FINAL
ENVIRONMENTAL IMPACT STATEMENT

F-15E BEDDOWN AT SEYMOUR JOHNSON AFB,
NORTH CAROLINA

November 18, 1988

MILITARY TRAINING ROUTE MAPS

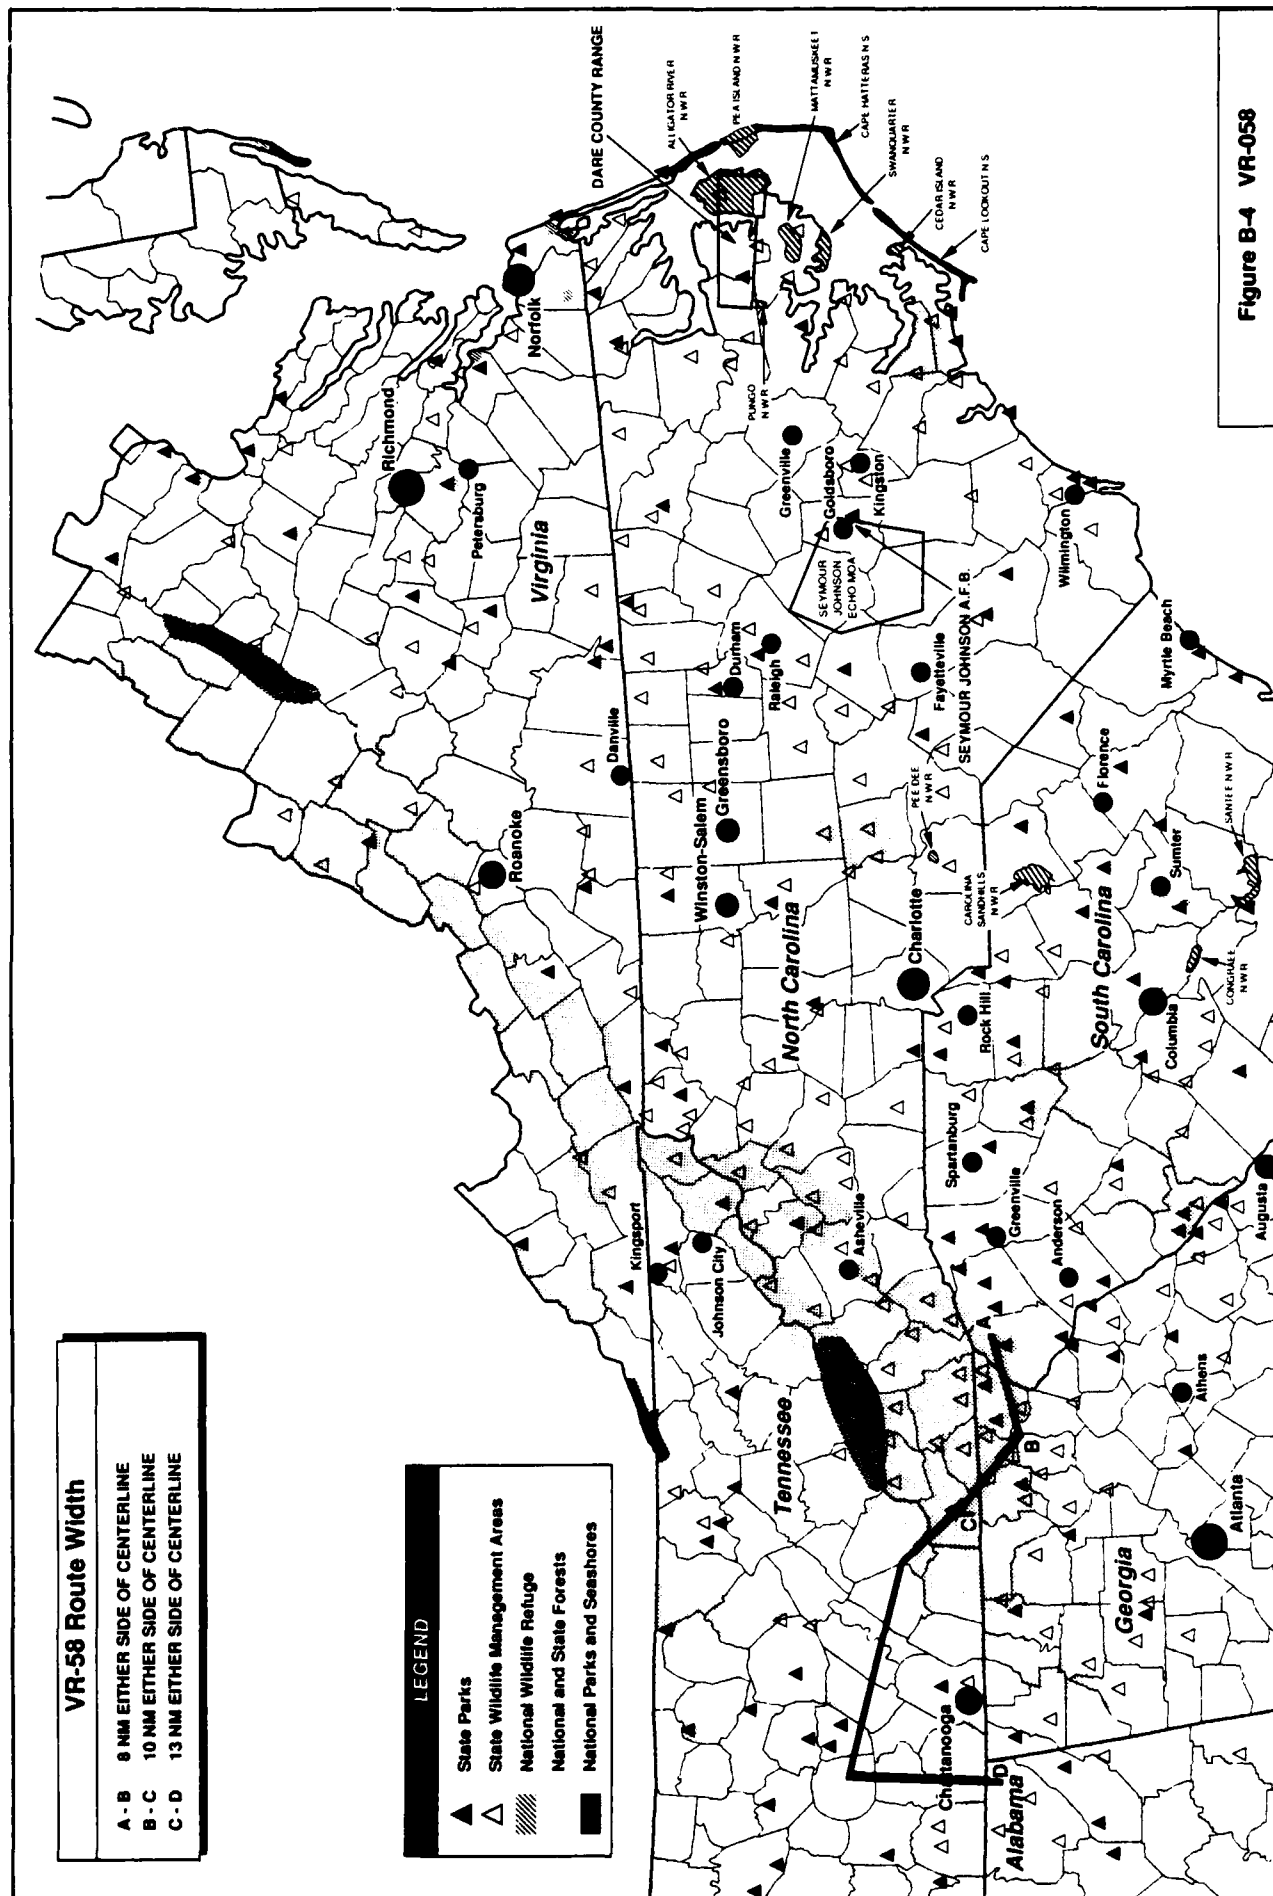
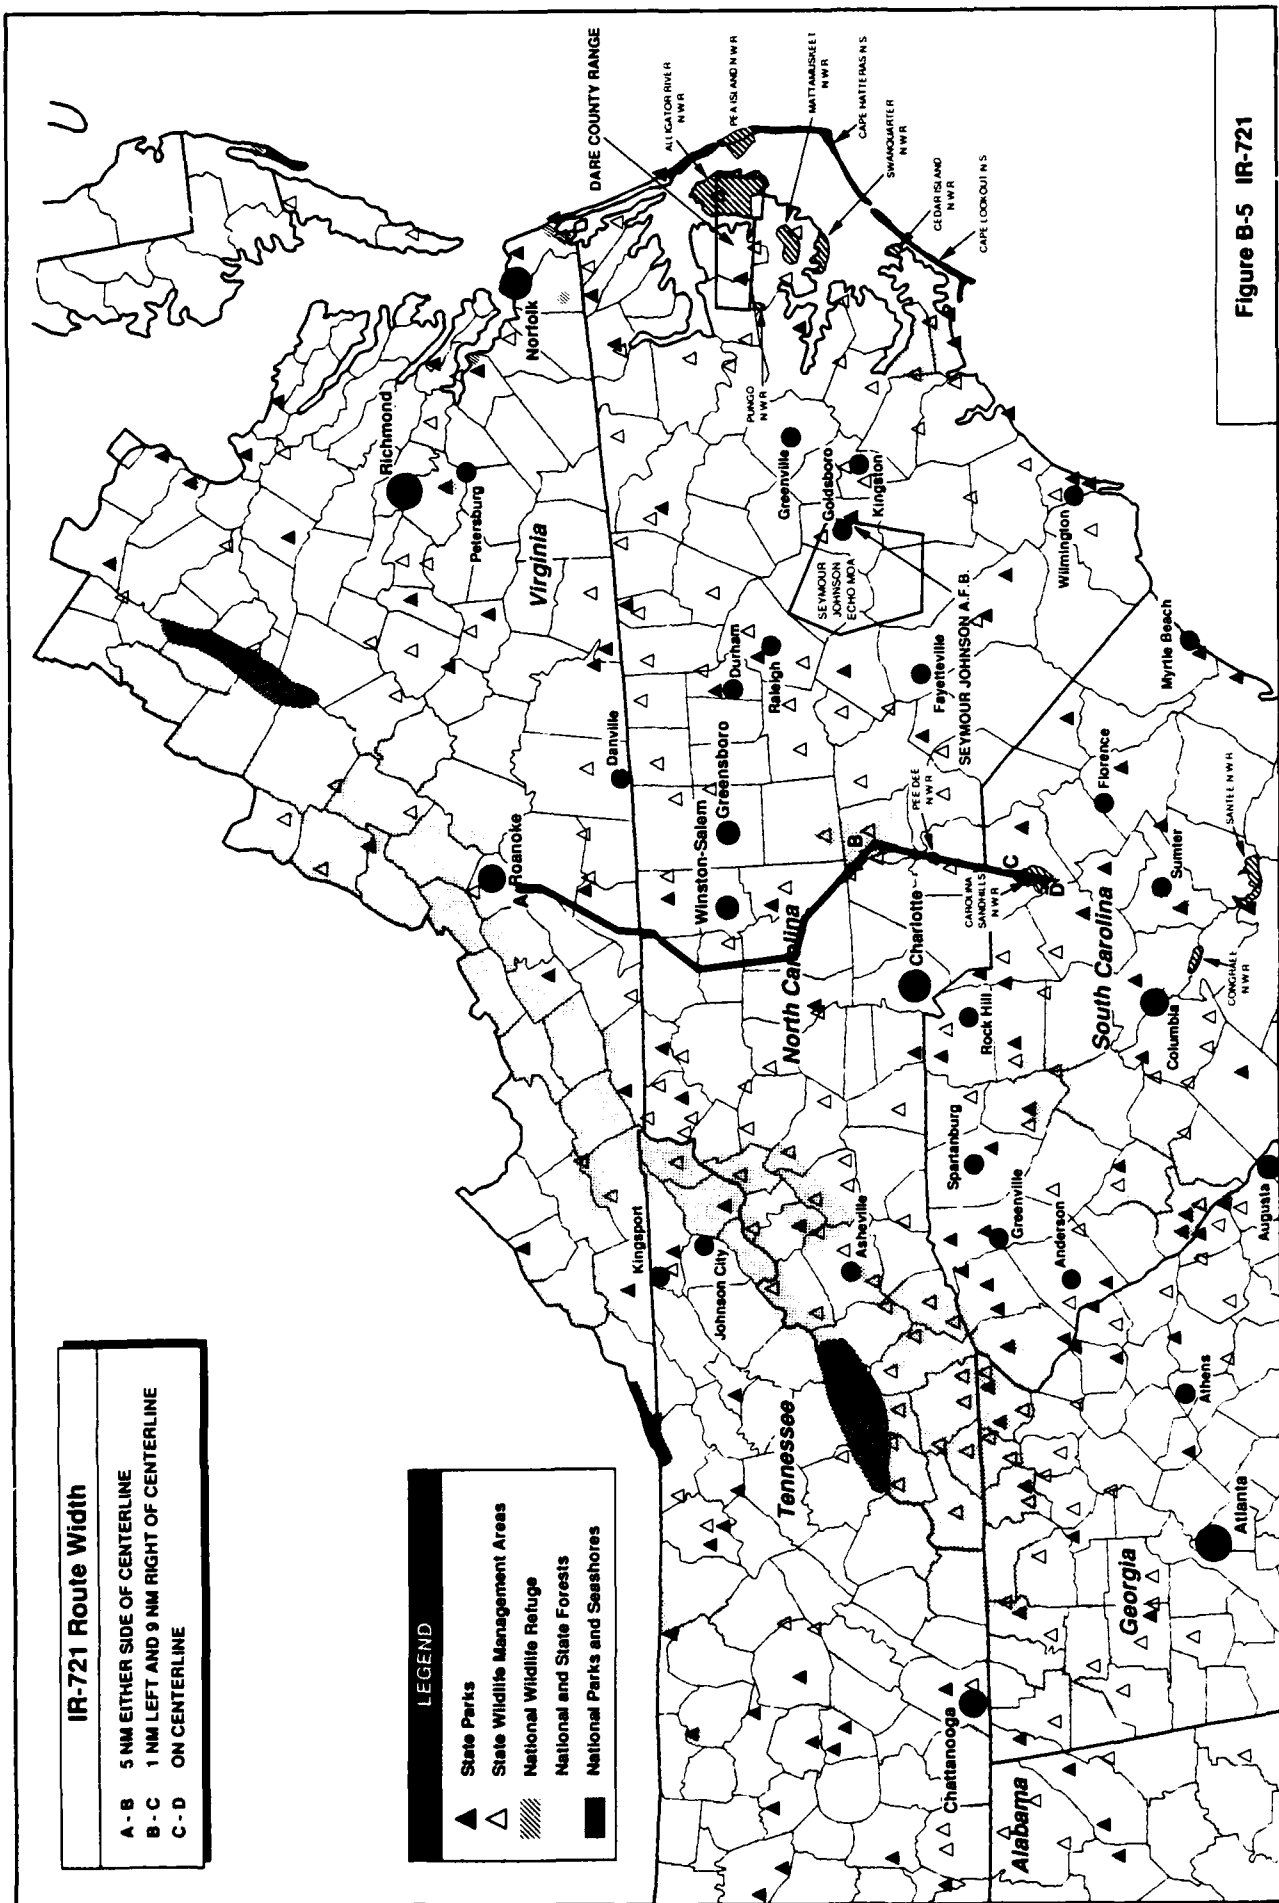
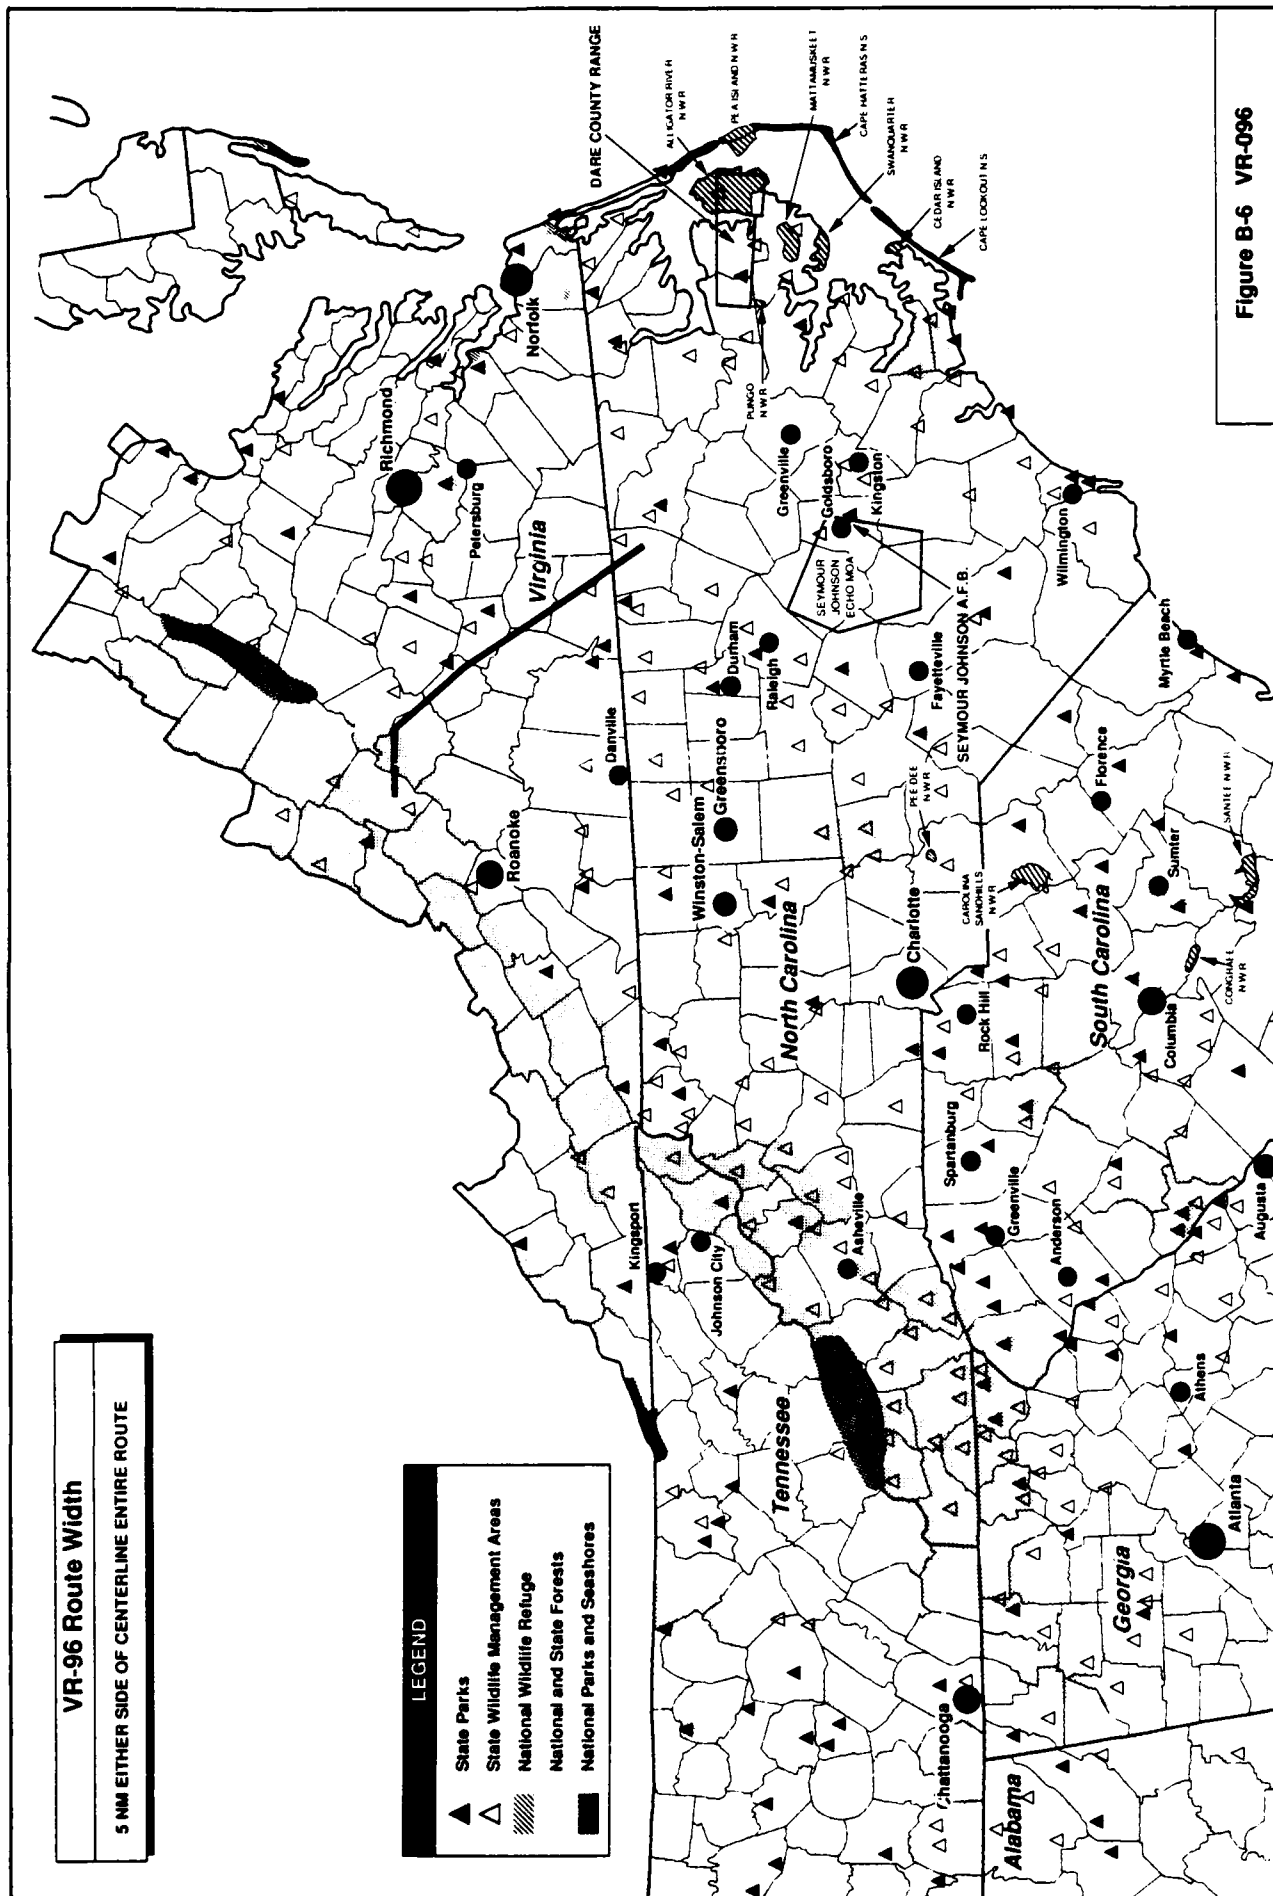
Page 3.0-3. Figure 3.0-2 only qualifies as a general representation of the MTR proposed for use and is not sufficient

to show their relationship with other facilities. For instance, neither R-5301 and 5302 nor R-5313, or Pamlico MOA are on the map. It is impossible to identify the location of any site in the interior of the state if it is not on the map.

77. The correct reference is to Figure 3.0-2. See errata (Chapter 5). Additional information on the location of "wildlife management and recreation areas" is provided in Appendix B.

13. p. 2.4-2, Table 2.4-1, Impact Area, No Action Alternative, and Proposed Action columns: Insert "Fire Potential", 0, and 0, respectively.
14. p. 3.0-3, Figure 3.0-2, VR-096 and VR-1043. Routes were drawn beyond legs specified in AP1B extracts for MTRs. See revised maps in Appendix B.
